Access Compliance Report

Public Rights-of-Way

(Curb Ramps)

Intersection ID: 8462	Main Street: ROLLING_HILL_DR	Cross Street: W_SUGAR_CREEK_RD	Location: SE
ADA ID: BA25565FFD05	Ramp Type: ParaDiag	Initial Pass/Fail: Pass	Overall Compliance: No
Severity Score: 0.25			
Codes/Mitigation Info/Possible Solution		Field Measurements/Component Compliance

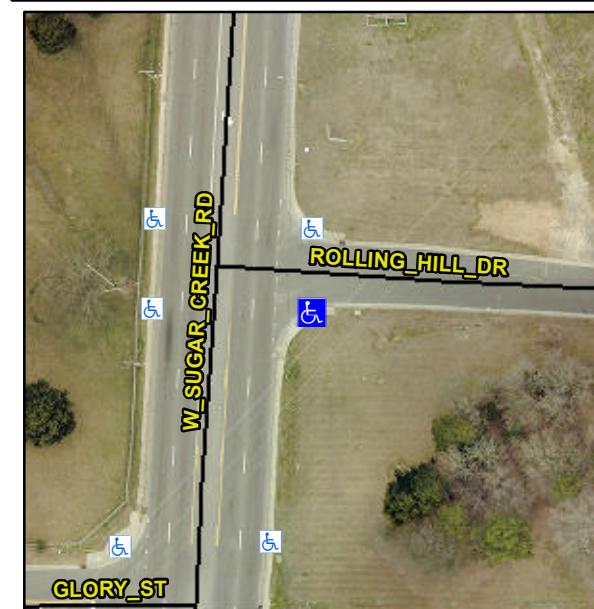
Remove & Replace Curb Ramp With Two New Directional Ramps or Equivalent. Gutter Ponding Observed.

RT RP < 5%

R304.5.3, R302.7
